PCAP TR2, Adequacy Review

Fremont Paving and Redi Mix Technical Revision
M2016-009
Pueblo County Aggregate Project
Narrative Description of Revision

Updated Map with Haul Roads and Processing 9.13.2023.pdf
9653K

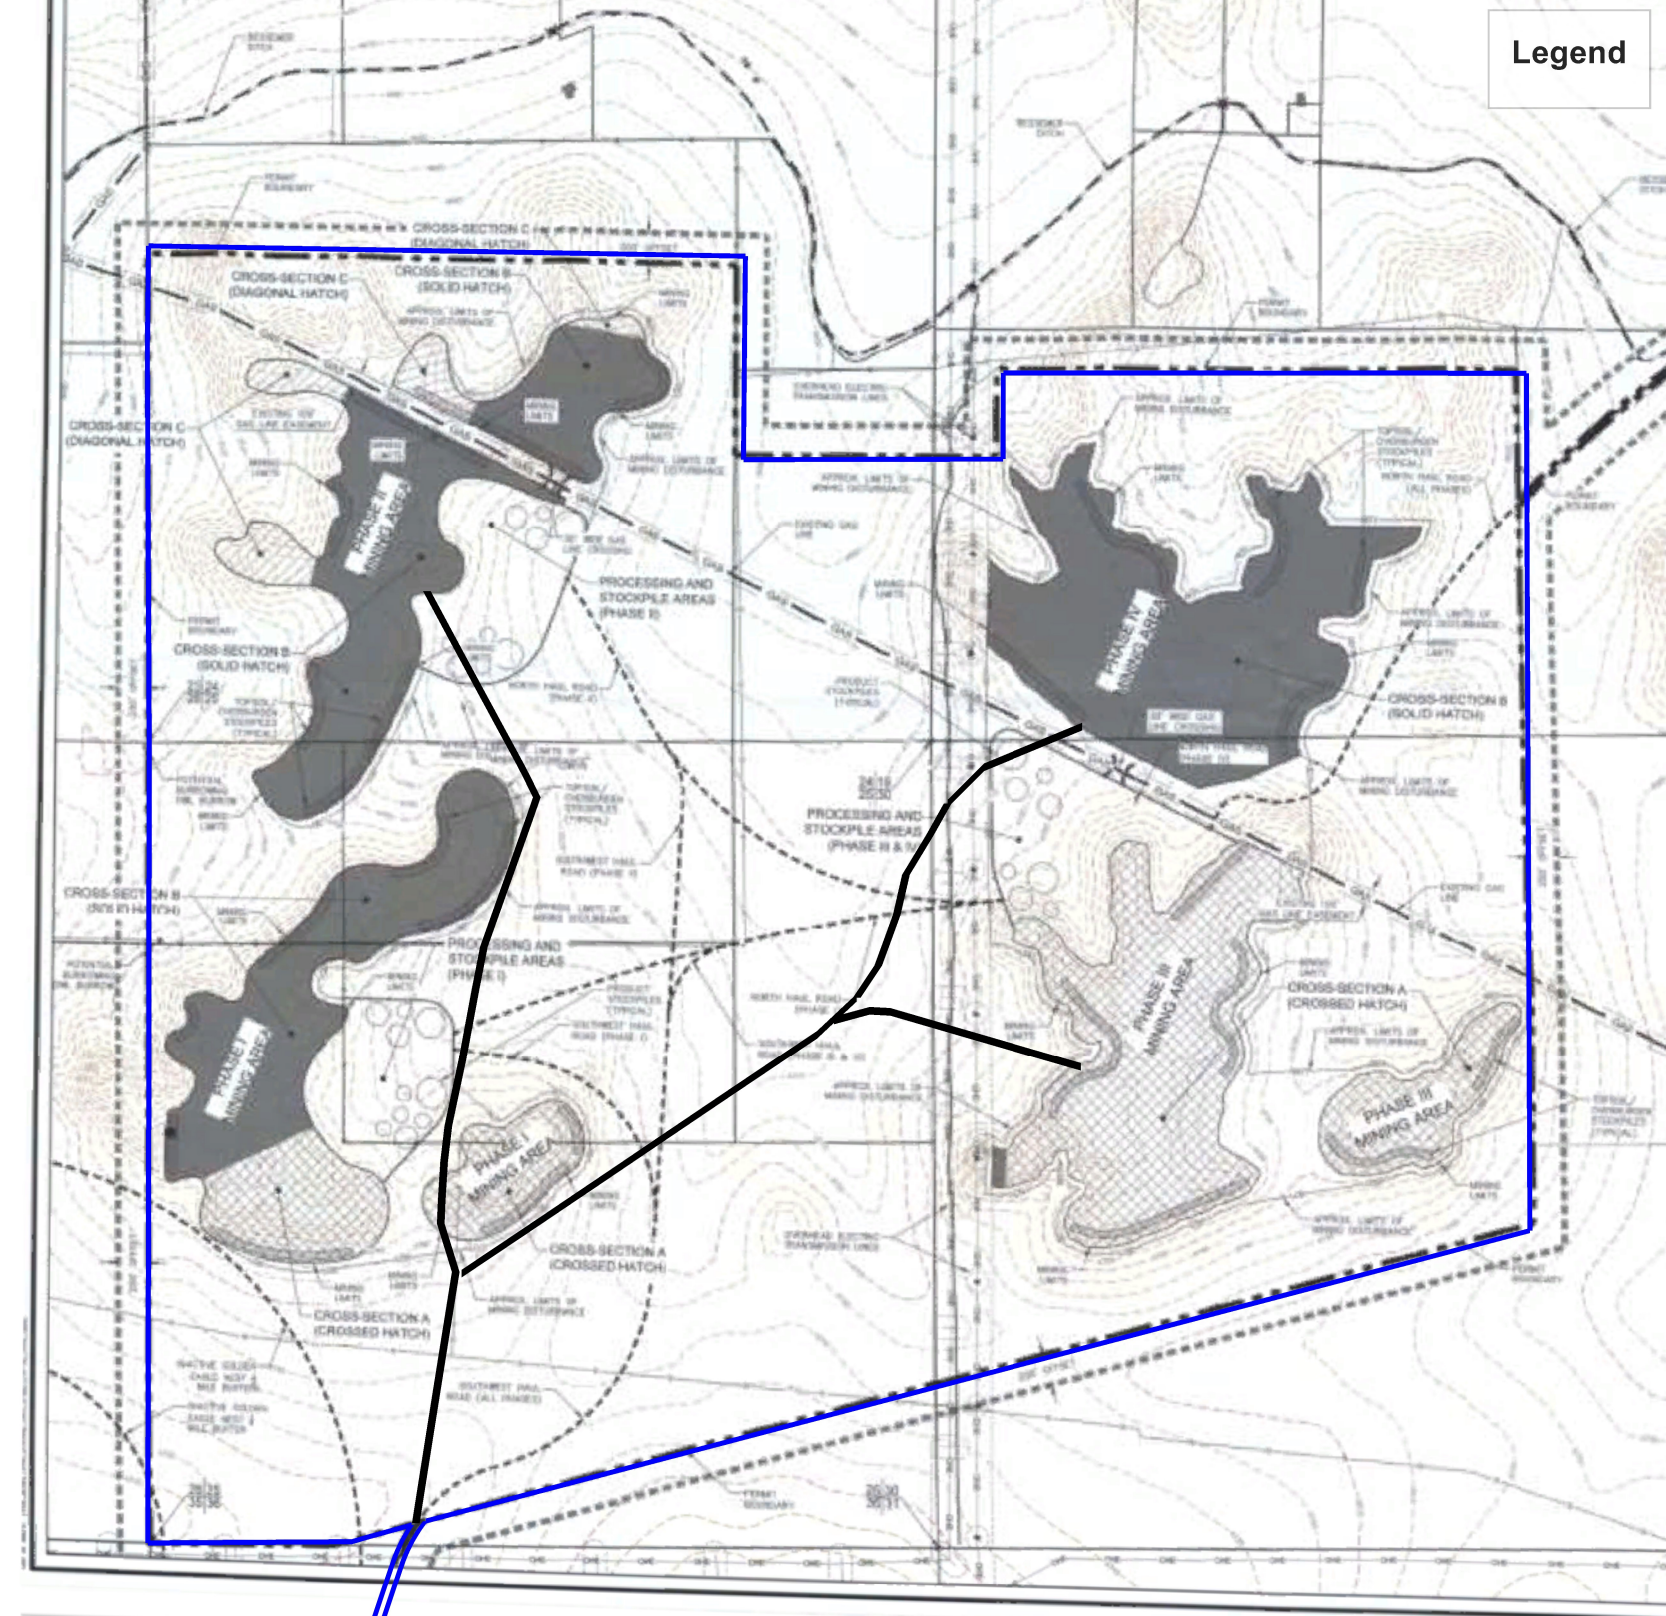
There was a glitch in the system when I was trying to submit the TR online and it appears the map never was attached to the submission. It is attached for your review to this email.

Fremont would like to submit a Technical Revision request to reduce the active mine area to 15 acres. Fremont commits to keeping the active mine area to 15 acres, plus 18.1 acres for the haul road. It is Fremont's understanding, as described in the first response to the recent inspection, that 15 acres will be actively mined following the reclamation of the previous 15 acres. All dirt work and the initial seeding would be accomplished prior to moving to the next 15-acre section. However, full vegetation need not be accomplished prior to moving to the next 15 acres.
